# Access Compliance Report

## Public Rights-of-Way

### (Curb Ramps)

Intersection ID: N/A	Main Street: HAMILTON_BRIDGE_RD	Cross Street: DALLAS_BAY_RD	Location: SE
ADA ID: E7721AF5A9F2	Ramp Type: Perp	Initial Pass/Fail: Fail	Overall Compliance: No
Severity Score: 12.5			
Codes/Mitigation Info/Possible Solution		Field Measurements/Component Compliance

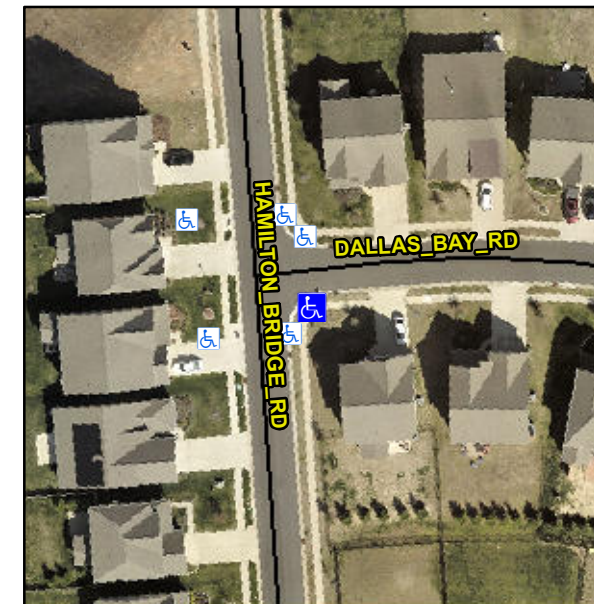
**Not Found, R304.2.2**

Compliance	Description	Data	Compliance	Description	Data
N/A	Ramp Length (in)	50.0	No	Ramp Slope (%)	11.7
Yes	Ramp Width (in)	48.0	Yes	Ramp XSlope (%)	1.6
N/A	Flare Type LT	N/A	N/A	Flare Type RT	N/A
N/A	Flare Slope LT (%)	N/A	N/A	Flare Slope RT (%)	N/A
N/A	Flare Traversable LT?	N/A	N/A	Flare Traversable RT?	N/A
N/A	Landing Length (in)	N/A	N/A	DWS Provided?	N/A
N/A	Landing Width (in)	N/A	N/A	DWS Contrast?	N/A
N/A	Landing Slope (%)	N/A	N/A	DWS Length (in)	N/A
N/A	Landing X Slope (%)	N/A	N/A	DWS Full Width?	N/A
N/A	Landing Curb? (Y/N)	N/A	N/A	DWS Offset (in)	N/A
N/A	Shared Landing?	N/A			
N/A	Gutter Ponding?	N/A	N/A	Gutter Slope (%)	N/A
N/A	Gutter Lip Ht (in)	2.0	N/A	Gutter X Slope (%)	N/A
N/A	Painted X Walk1?	No	N/A	Painted X Walk2?	N/A
	X Walk 1 Direction	To N		X Walk 2 Direction	N/A
N/A	X Walk 1 Width (in)	N/A	N/A	X Walk 2 Width (in)	N/A
	X Walk 1 Slope (%)	2.3		X Walk 2 Slope (%)	N/A
	X Walk 1 X Slope (%)	0.5		X Walk 2 X Slope (%)	N/A

**Remove & Replace Entire Ramp.**
